STATE OF NORTH CAROLINA
DEPARTMENT OF TRANSPORTATION

April 12, 2013

Subject: **Additional Information in Response to the N.C. Division of Water Quality's On Hold Letter for the Modification Request of the Individual Section 404 and Section 401 Water Quality Certification** for the proposed improvements to NC 24 from SR 1853 (John Nunnery Rd.) in Cumberland to US 421-701/SR 1296 (Sunset Avenue) in Sampson County. Federal Aid Project No. STPNHF-F-8-2(17), TIP No. R-2303B, C, and D.

R-2303C Application Comments

Permit Drawing Sheet 15 of 80

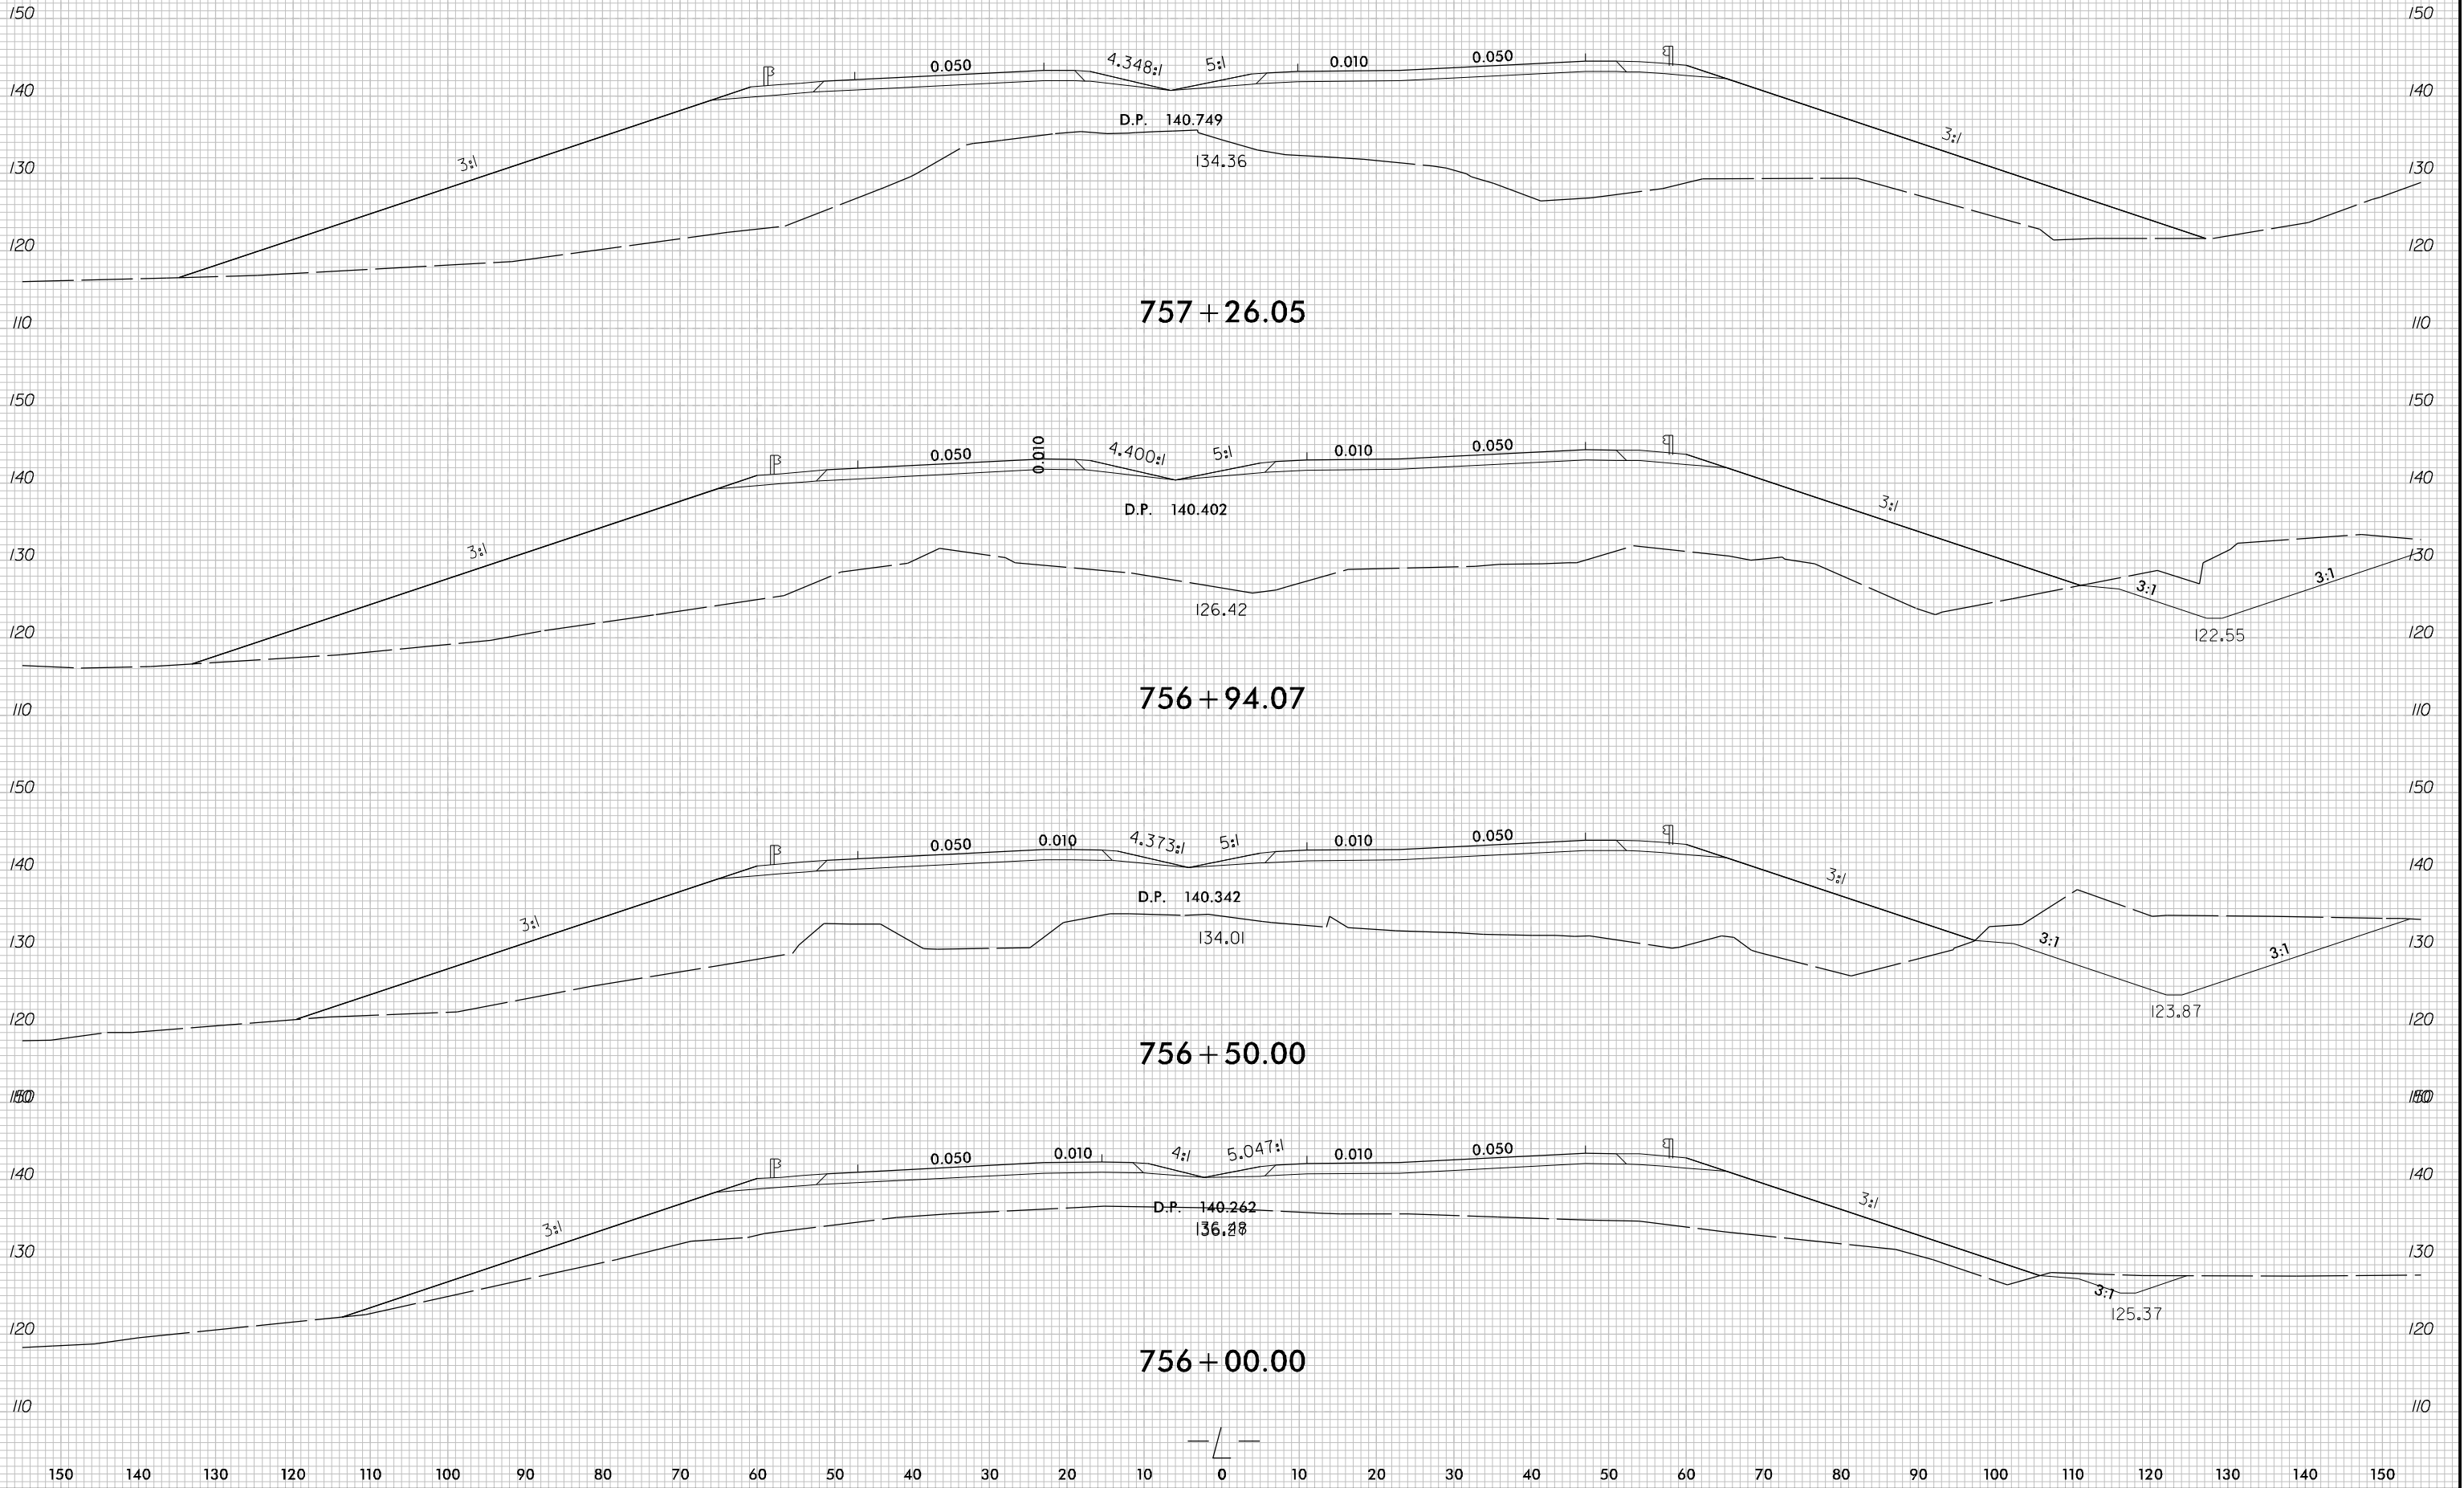
2. Please provide cross sections for Sta. 752+00 to 766+00 (Sites 3 and 4).
Cross sections added to the permit drawings.
3. Permit drawing 16 of 75, cross section 774+00 shows 4:1 slopes at this jurisdictional crossing. Your application states in the “Minimization and Avoidance” section states that 3:1 slopes will be used in jurisdictional areas. Please correct.
Slopes have been revised to 3:1.

Permit Drawing Sheet 28 of 80

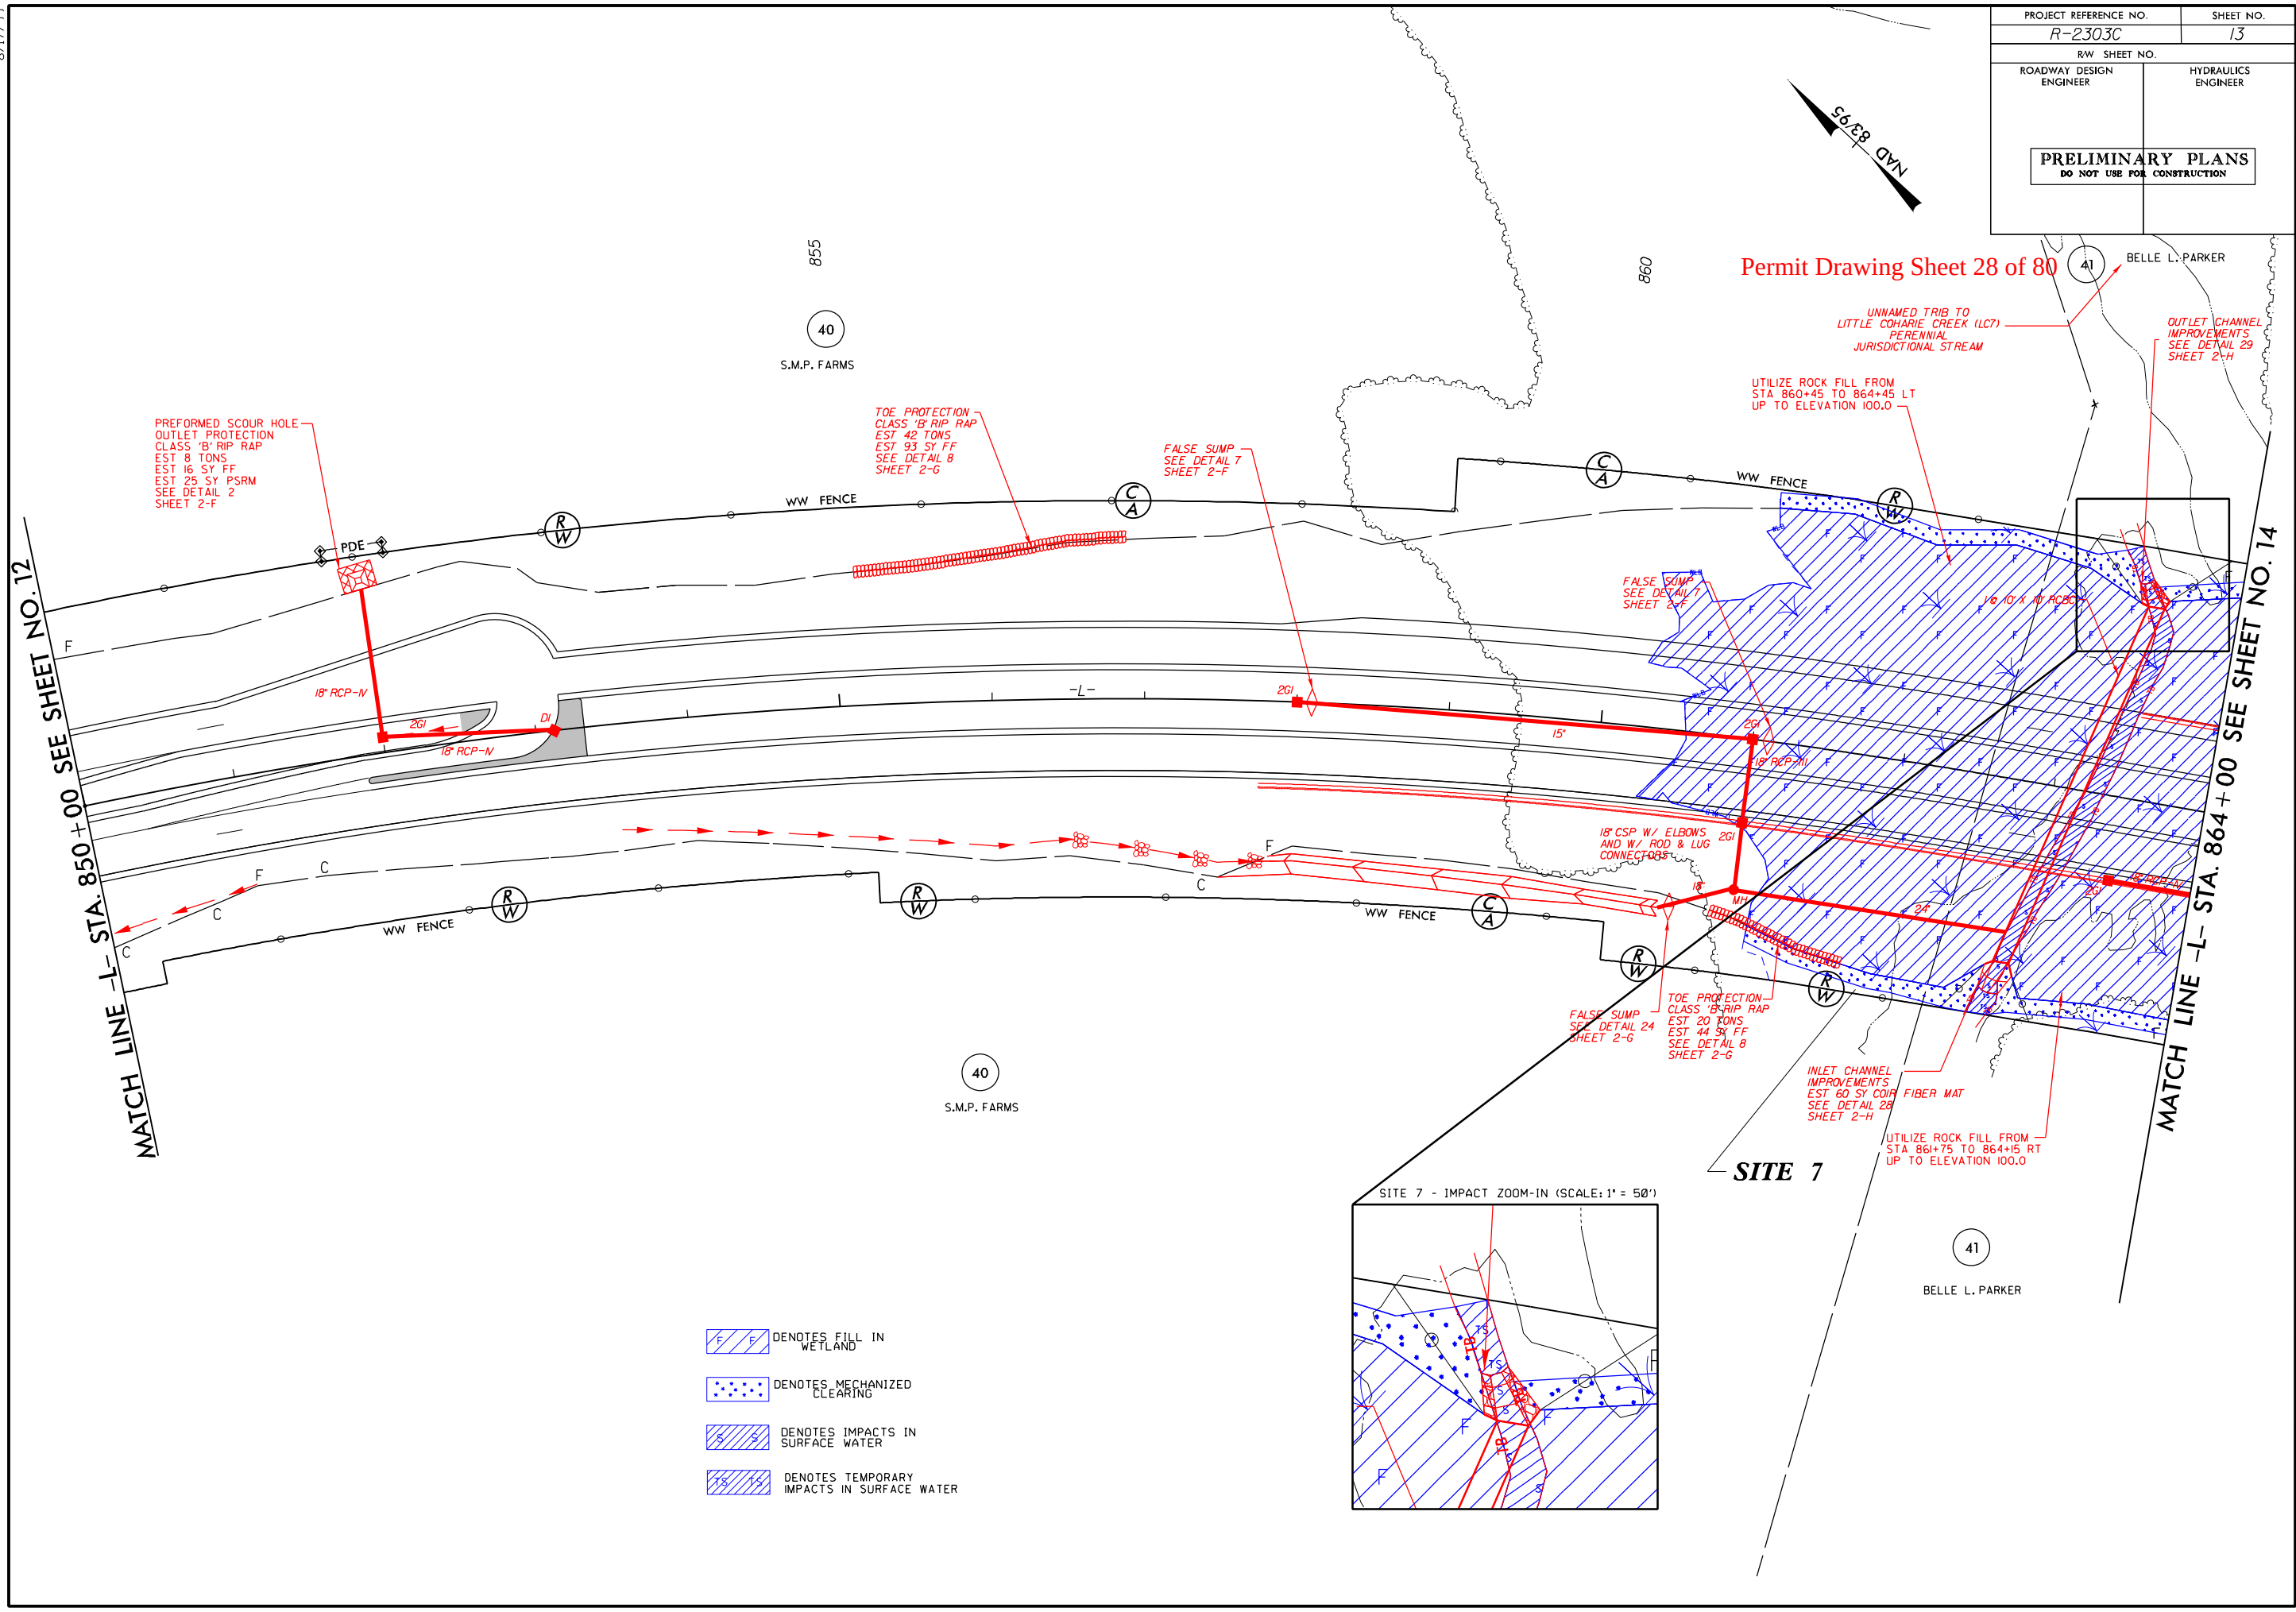
6. Permit drawing 27/28 of 75, Site 9 shows wetlands impacts within –D7-, this was brought up at 4C and was never clarified. Please clarify. If wetlands do exist within existing –D7-, can –D7- be relocated outside of wetlands?
Per NCDOT Roadway, drive must remain to provide access to the parcel and no alternative to avoid wetland impacts are available.

Permit Drawing Sheet 34 of 80

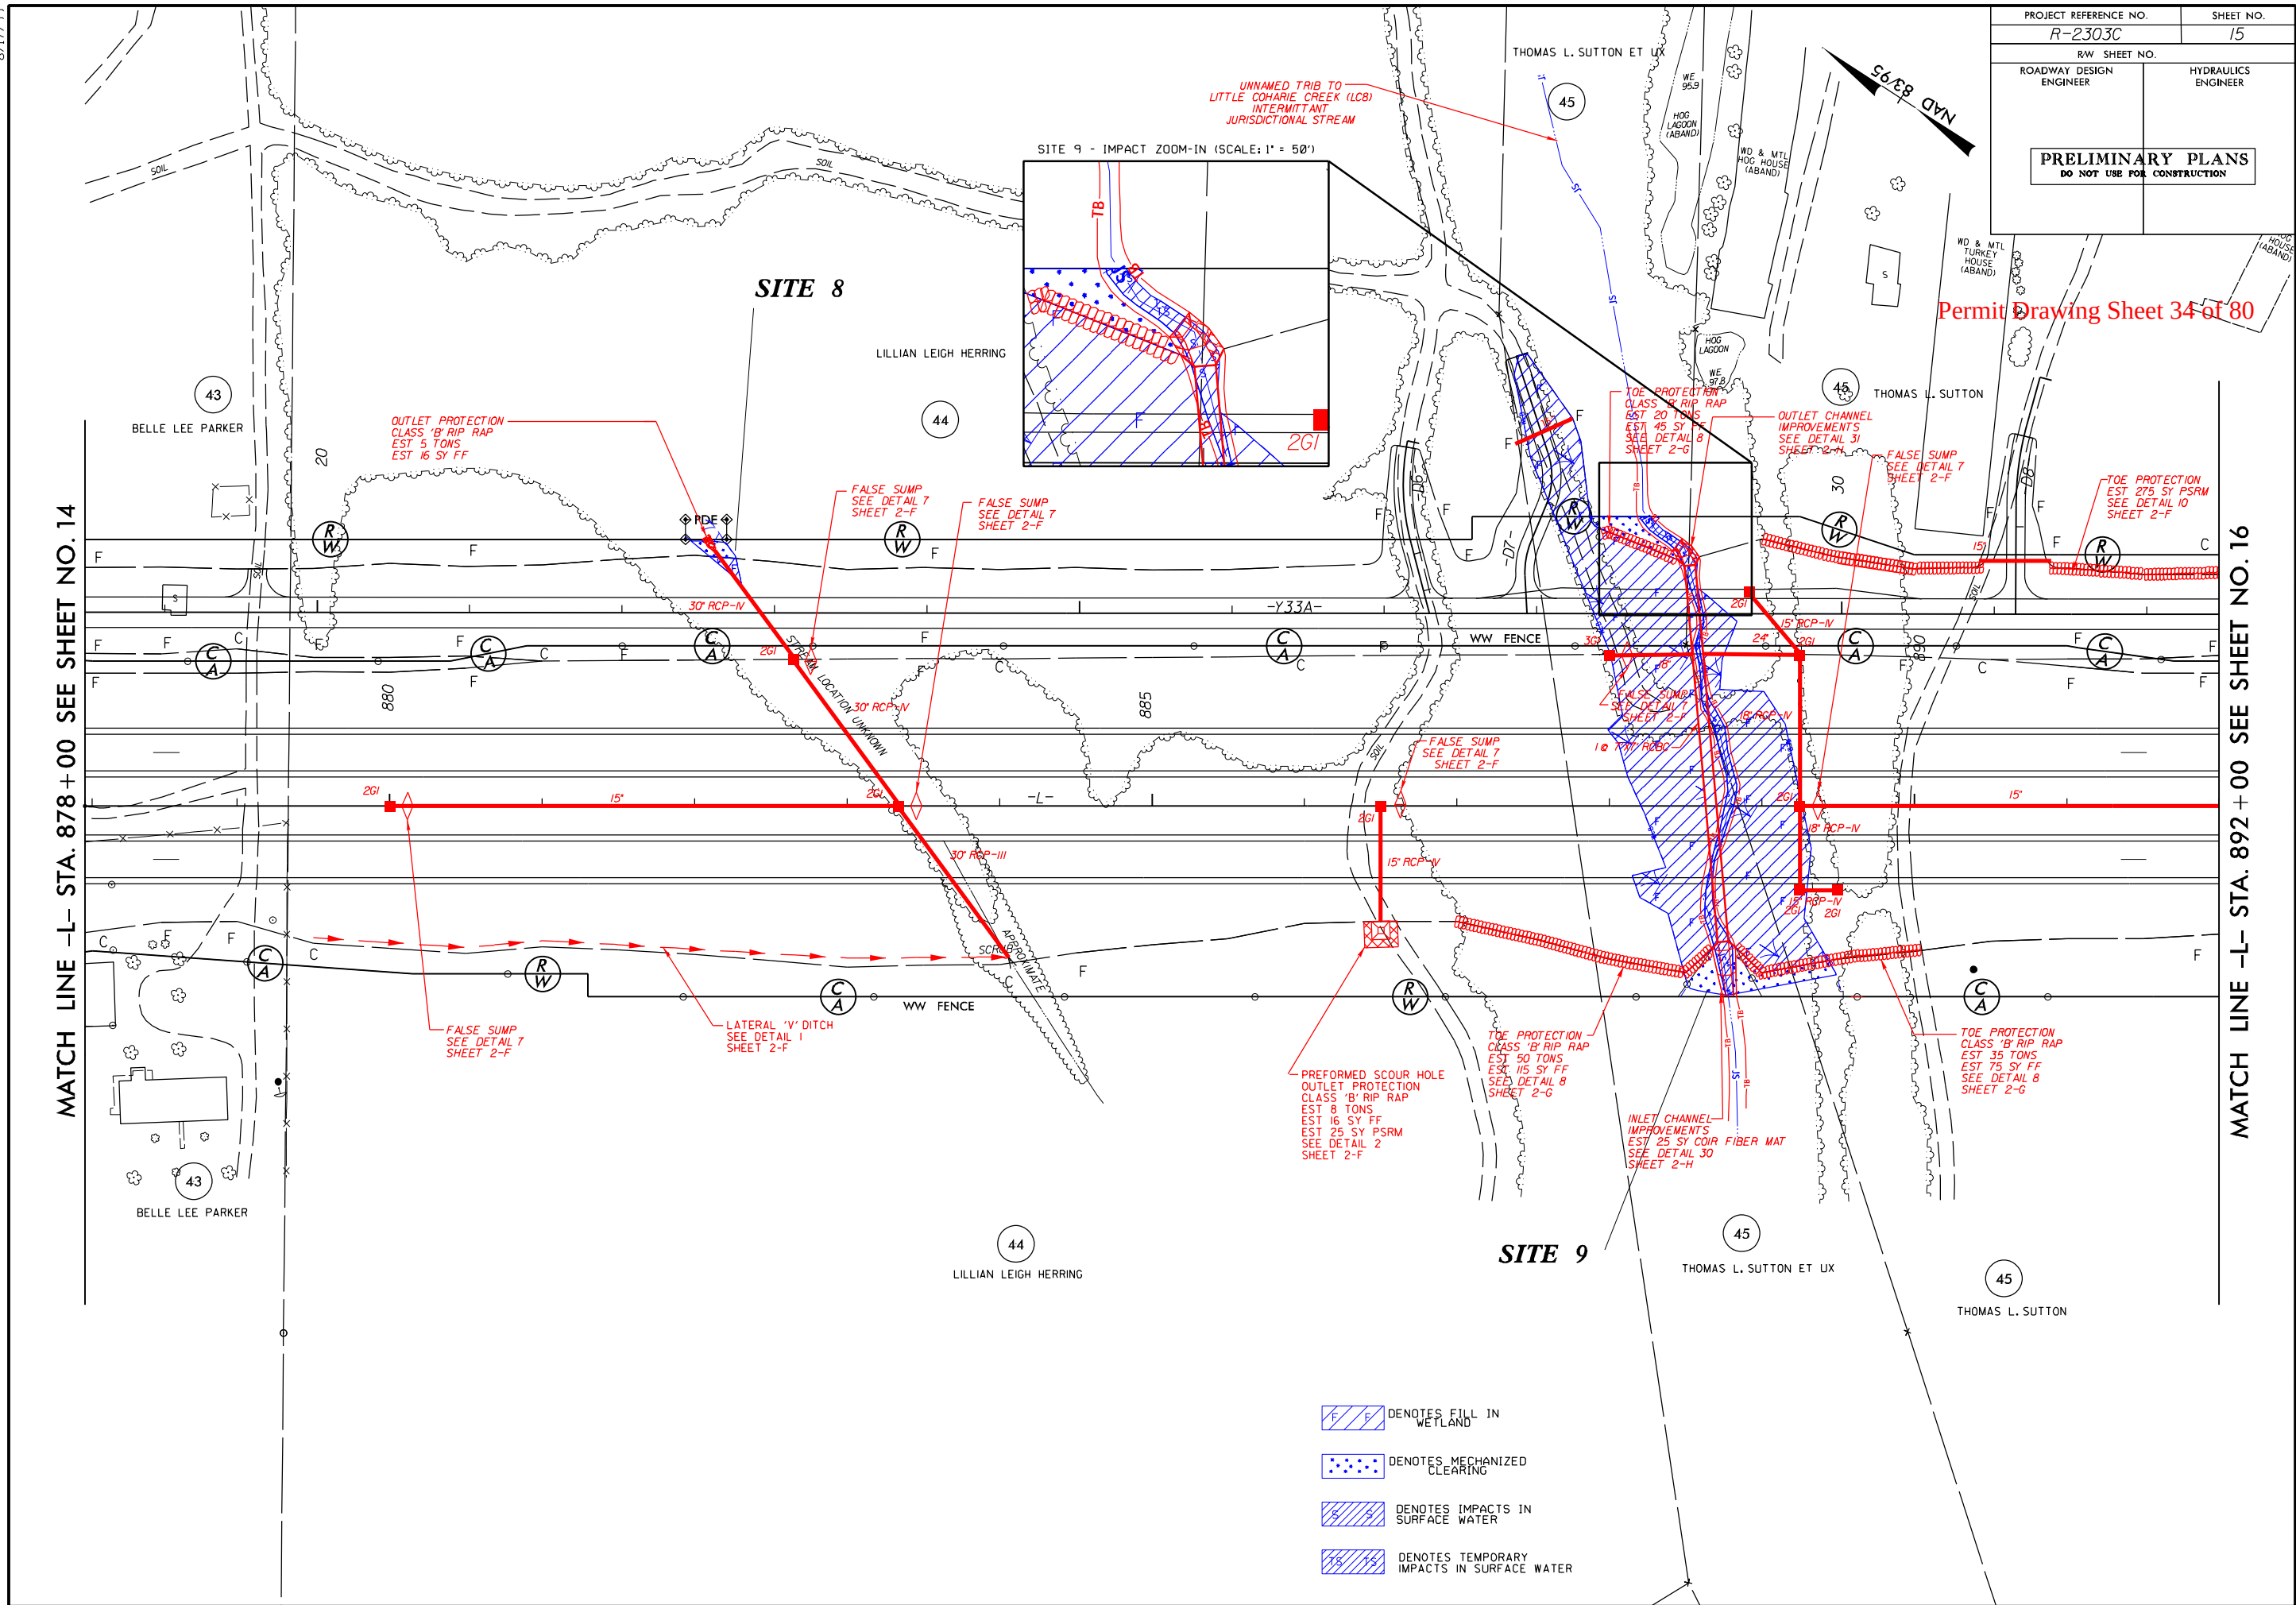
7. Permit drawing 34-35 of 75. Impact summary sheet list 315 lf of stream impacts at Site 11, however the permit drawing scale indicates approximately 190 lf of stream impact. Please clarify.
The length of the “impacts in surface water (pond)” were included in the length.
